**CITY OF WEST DES MOINES
PLAN AND ZONING COMMISSION COMMUNICATION**

Item: 3900 Westown Teller Canopy Removal, 3900 Westown Parkway - Approval of demolition of an existing bank canopy– Jerry's Homes Inc. – MML1-003450-2017

Requested Action: Approval of a Minor Modification to a Site Plan, Level 1

STUDIO MELEE
1312 LOCUST STREET, SUITE 1007
DES MOINES, IOWA 50309
(515) 314-9852
(515) 493-0003
JERRY'S HOMES
3900 WESTOWN PARKWAY
WEST DES MOINES, IOWA 50265
REMODEL AND TENANT FINISHES
PRINT DATE: MAY 19, 2017
SHEET NAME: PHASE 1 SITE AND DEMO OF CANOPY & DEFERRED PARKING
SP1

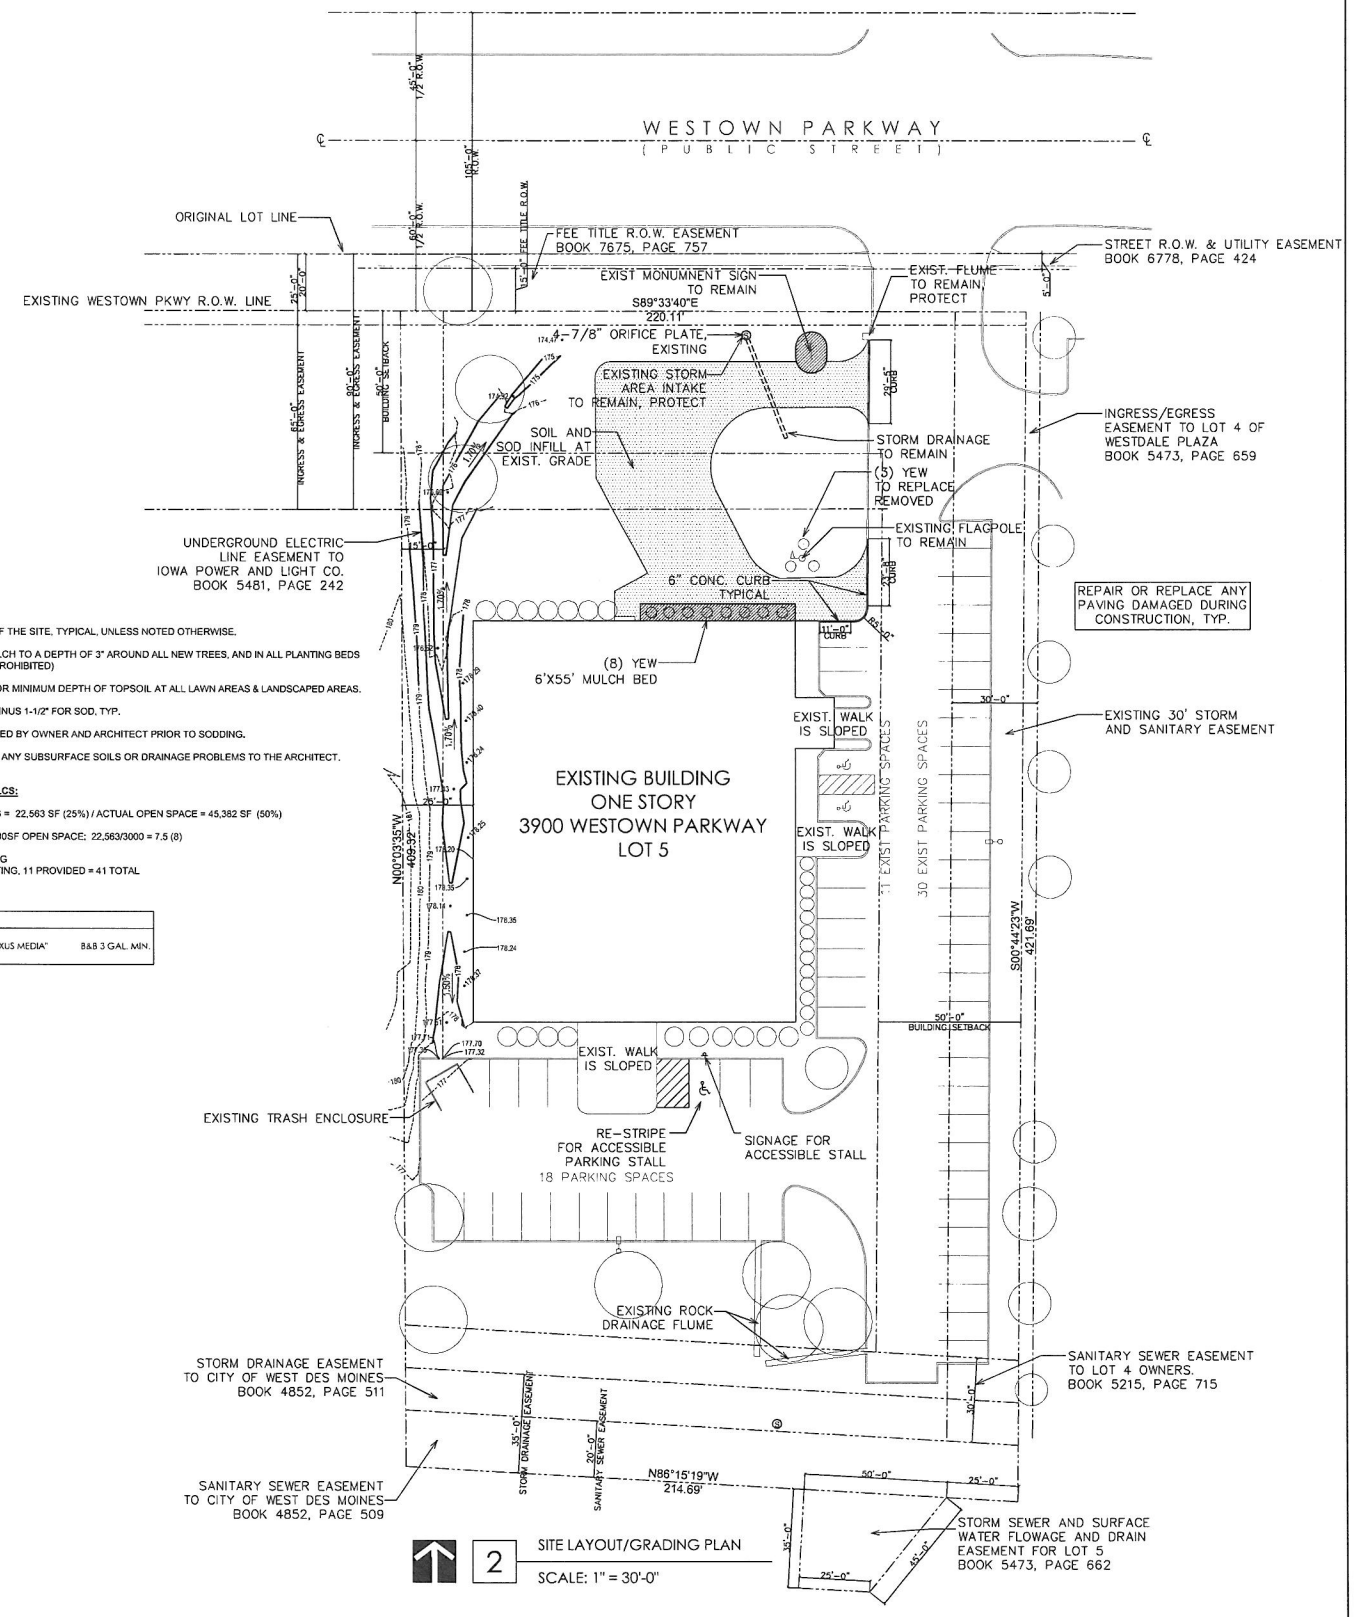
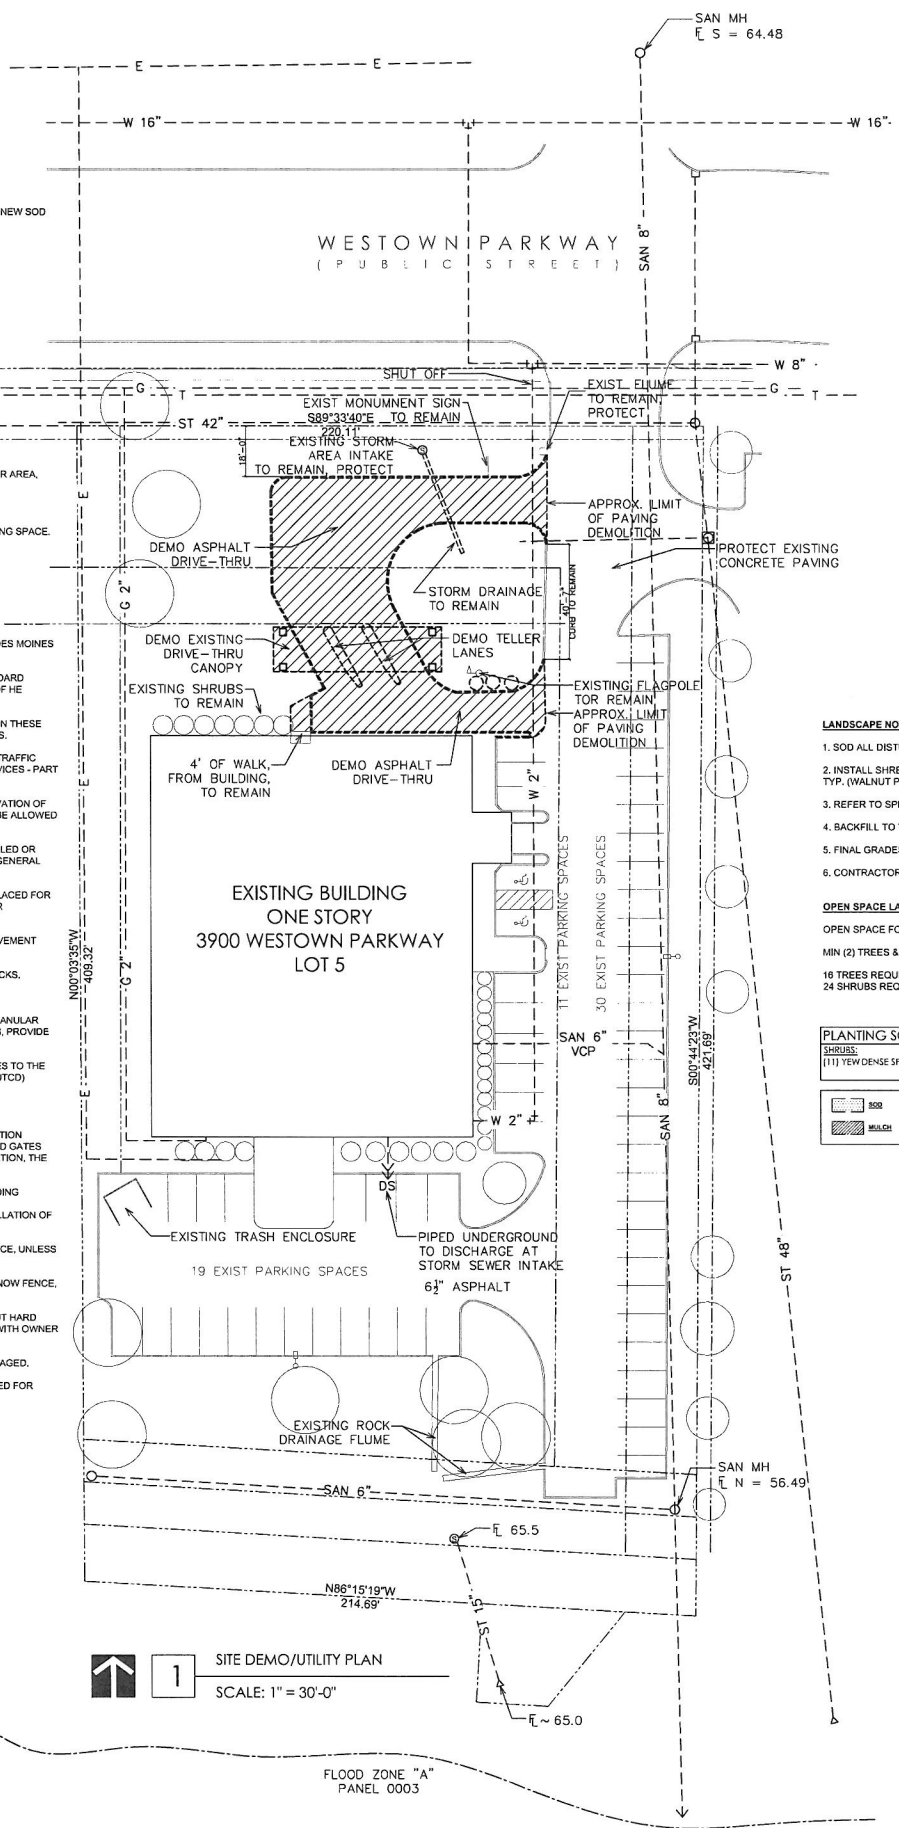
- *Parking Space Deferral:* Per City Code this 15,732 square foot build with the proposed office uses would require 1 parking space per every 200 square feet of gross floor area. This equates to 79 required parking spaces. The applicant is only proposing 59 spaces and is requesting that the City Council allow defer construction of 20 parking spaces until they are deemed necessary by the City Council. The reason behind the applicants request is that the building have had the same number of parking spaces since it was built in 1985 and that the type of office uses have been constant since that time without issue. Staff researched the history of this development and discovered that the site has a legal non-conforming status for parking. Prior to 1996 the City had a lower parking requirement for office uses. This lower requirement made the existing 59 spaces parking a non-issue when the drive-thru canopy was built. In this proposal, the applicant is proposing to demolish the canopy and the drive and cover the area with turf. Given the history, Staff is comfortable with the request, but recommends the following condition:

- *The City Council deferring the installation of up to 20 parking stalls of the 79 required by Code until such time that parking on non-designated parking areas or parking off-site occurs due to the lack of available parking stalls. At that time, the City reserves the right to provide the applicant notice to increase the number of parking stalls. The applicant will be required to provide the additional parking spaces in accordance with City regulations within the first available construction season. Should the implementation of additional parking be needed, the applicant shall construct them in compliance with the plans submitted with this Site Plan that identifies the location and engineering details for the stalls to be constructed.*

3. The City Council deferring the installation of up to 20 parking stalls of the 79 required by Code until such time that parking on non-designated parking areas or parking off-site occurs due to the lack of available parking stalls. At that time, the City reserves the right to provide the applicant notice to increase the number of parking stalls. The applicant will be required to provide the additional parking spaces in accordance with City regulations within the first available construction season. Should the implementation of additional parking be needed, the applicant shall construct them in compliance with the plans submitted with this Site Plan that identifies the location and engineering details for the stalls to be constructed.
